JNU: GLACIER HWY MULTI-USE SEPARATED PATH TO UAS

PROJECT No. 0933037 ~ 69500

Change Order

Project No.: 69500/0933037 Change Order No. 20

MSE WALL TYPICAL

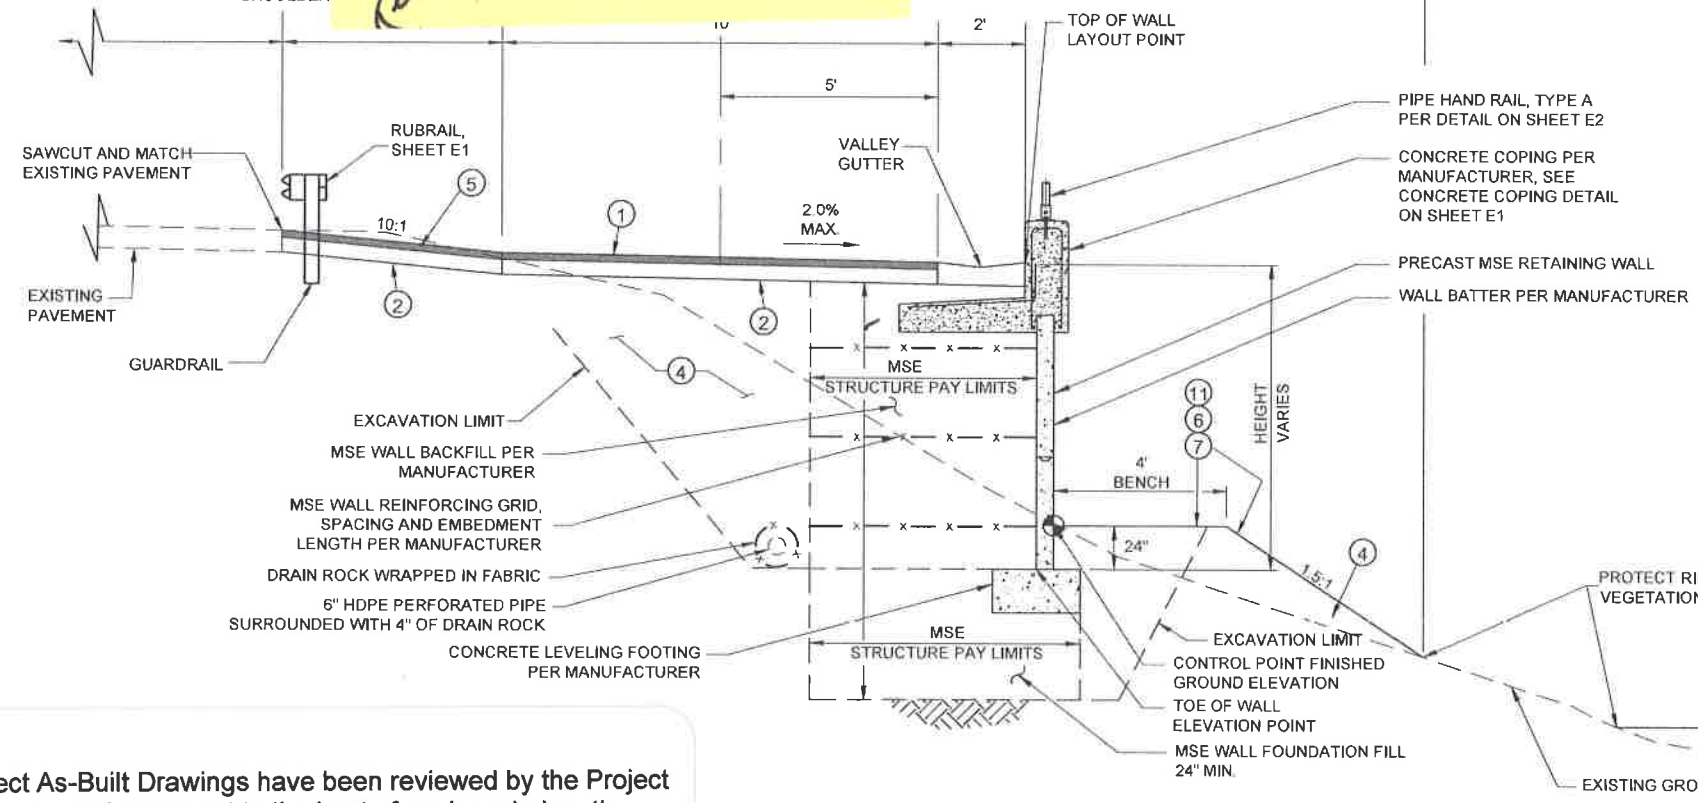
ITEM	UNIT	PRICE	QUANTITY	AMOUNT
MSE Concrete Wall-Pattern Finish	S.F.	\$100.00	-2,216.0	-\$221,600.00
MSE Concrete Wall-Pattern Finish	S.F.	\$124.00	+3,490.0	+\$432,760.00
TOTAL THIS CHANGE ORDER				+\$211,160.00

SETTLEMENT PLATE DETAIL

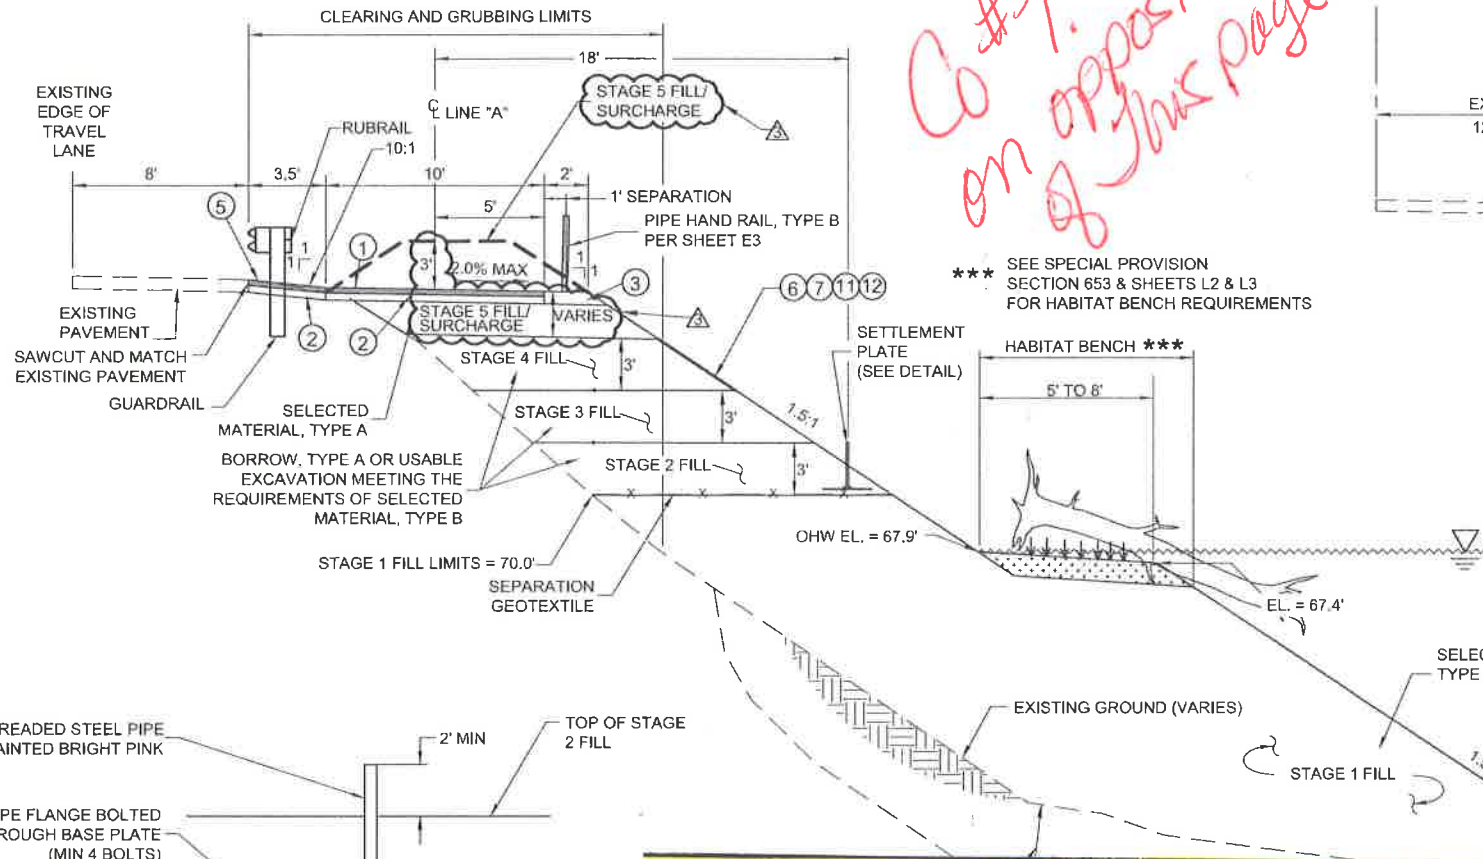
Reduce Existing Item 630(1)A Geotextile, Separation by 2,259 square yards.

Establish New Item 630(3)A Geotextile, Separation (200)

MSE WALL TYPICAL
 STA. 24+20 TO STA. 24+90
 STA. 26+15 TO STA. 27+40
 LINE "A"

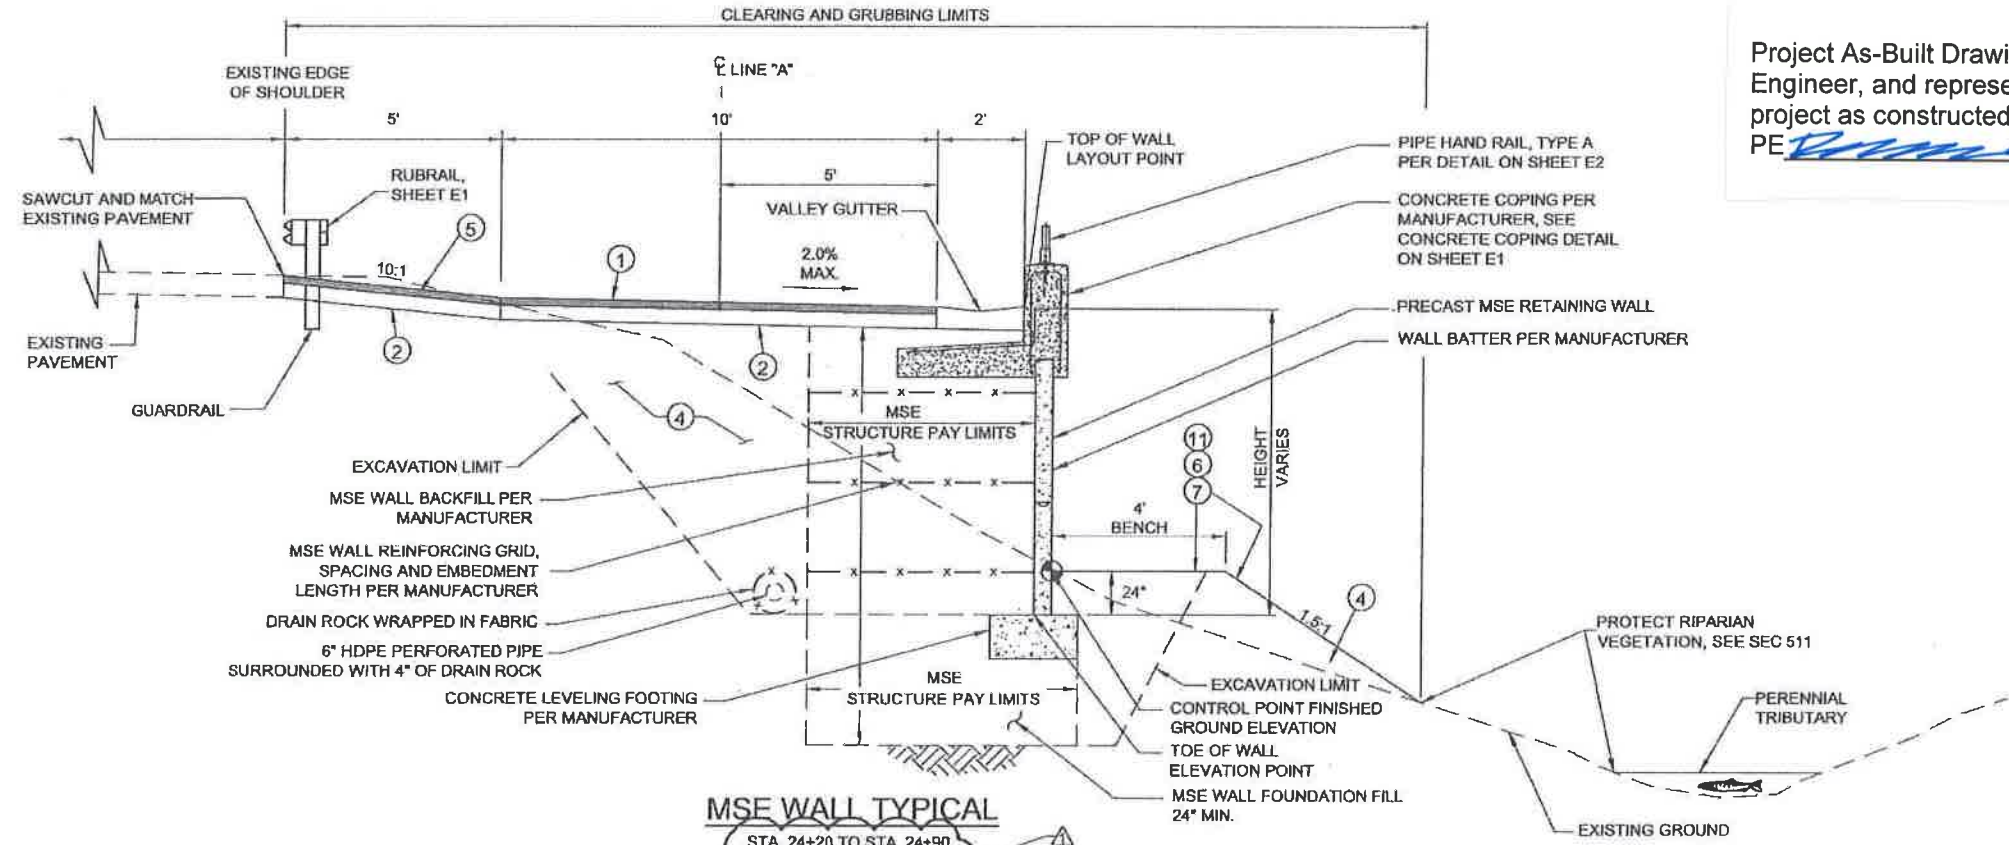
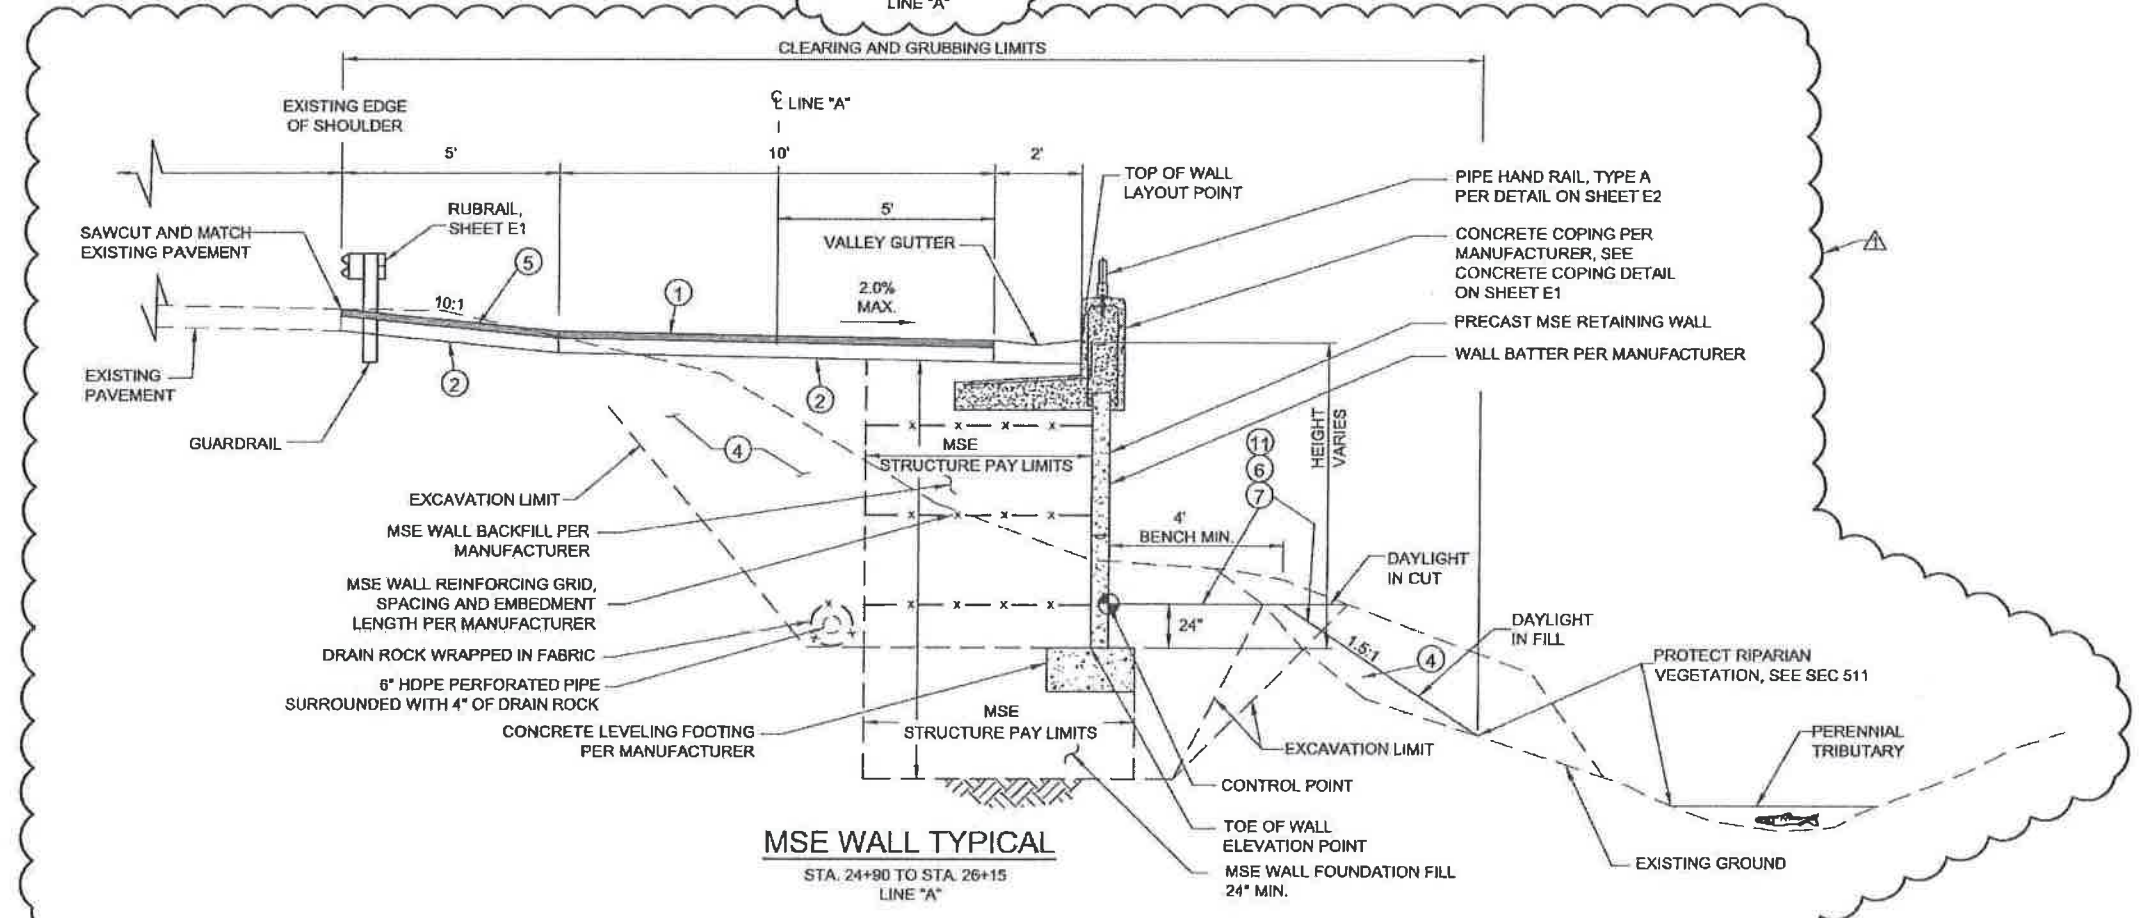
Reason for Change Order
 This is a material change to a major bid item. The original MSE Wall design had to be completely replaced to accommodate a new typical section and avoid conflict with the adjacent fish stream. The new section increases the depth, increases the block quantities, requires additional excavation, shoring, sheeting, a stepped footing, larger blocks, additional engineering, and additional ESCP control.

Replace Sheet B3 and M1 with the attached Sheet B3 and M1.

Delete Item 511(1A)a MSE Concrete Wall - Pattern Finish

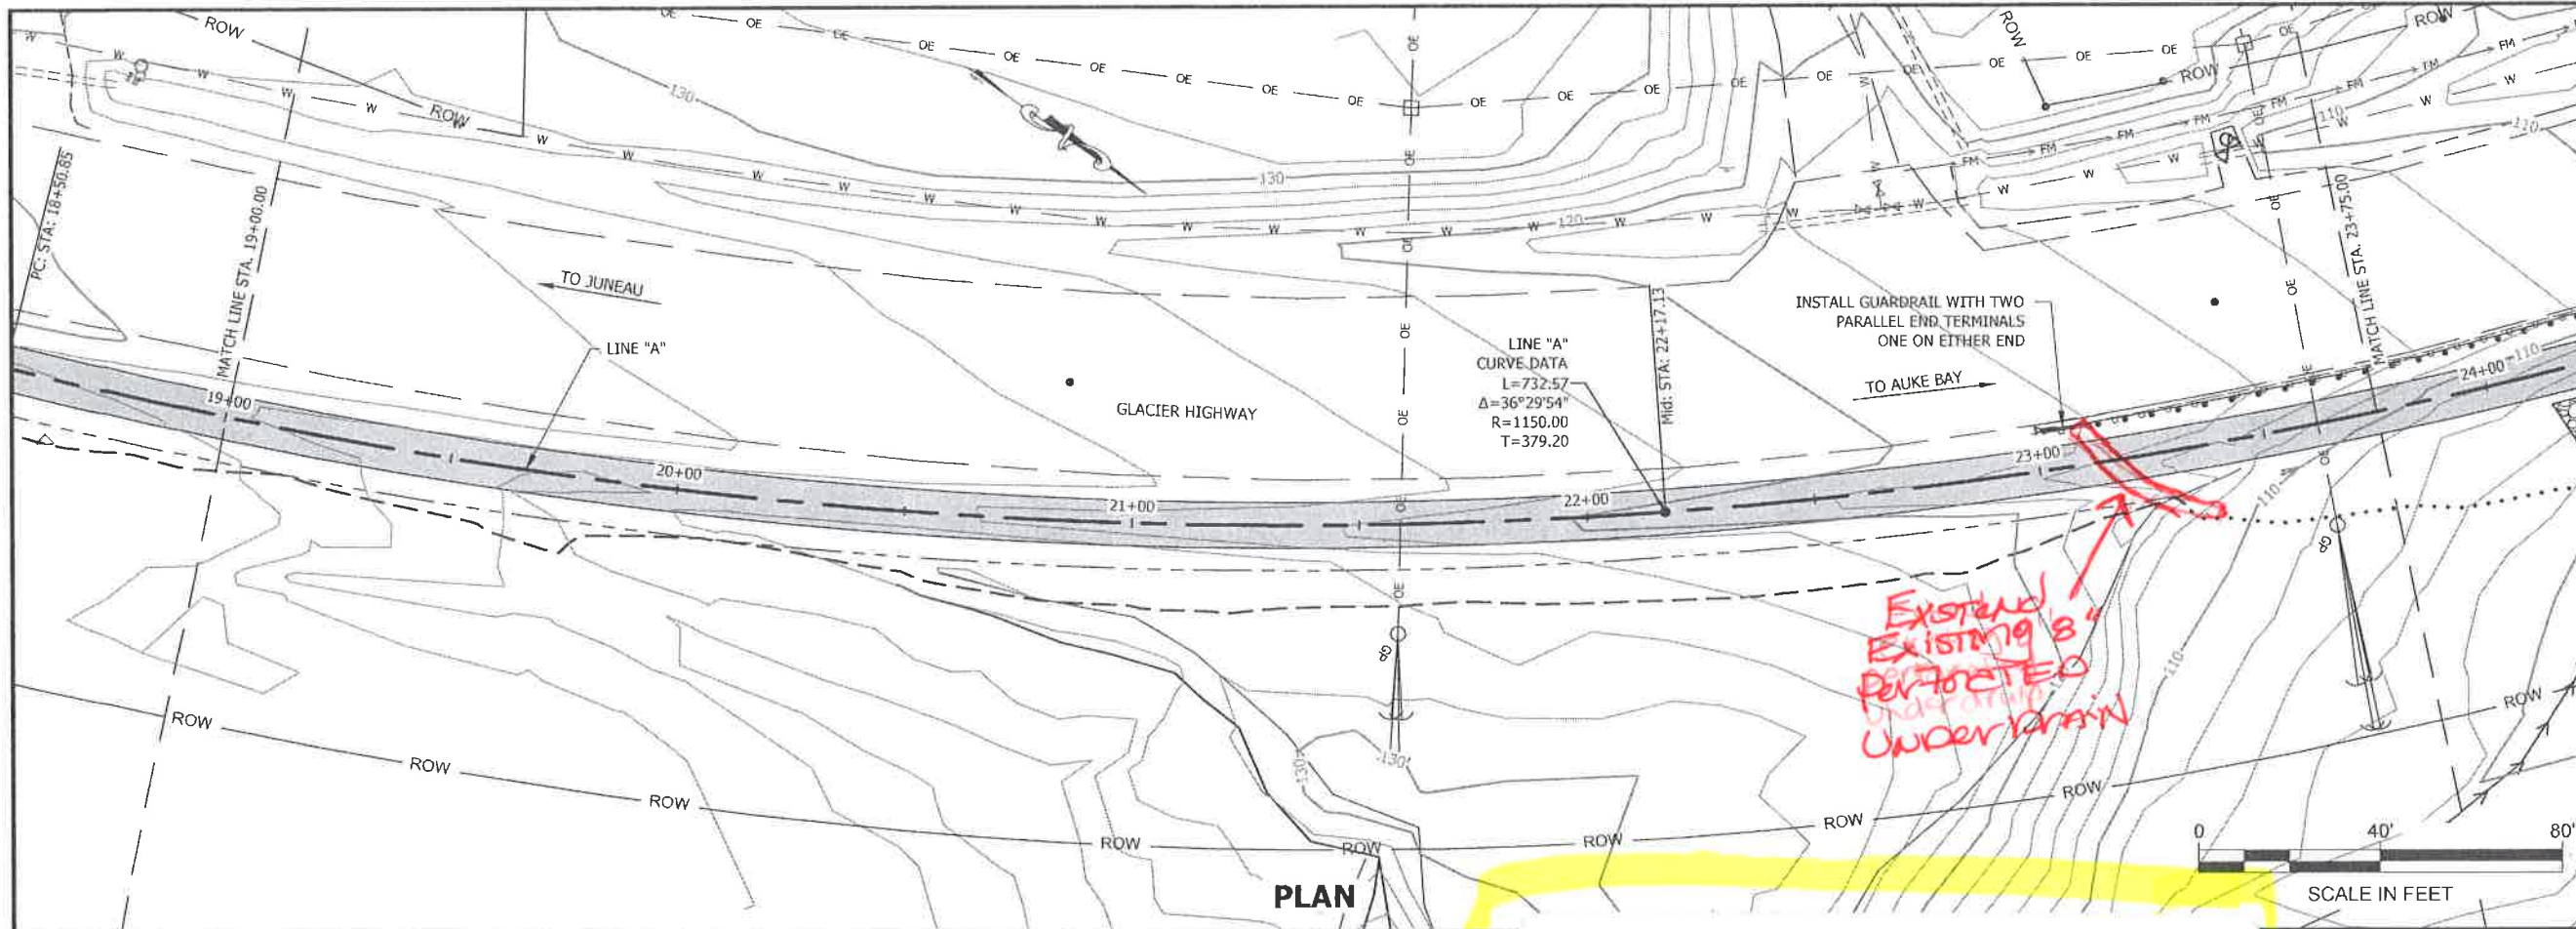
Establish New Item 202(15)a Removal of Existing Septic Tank

Description: Remove and dispose of the existing decommissioned septic tank at Station 16+75 RT to lay the slope back to the planned slope.
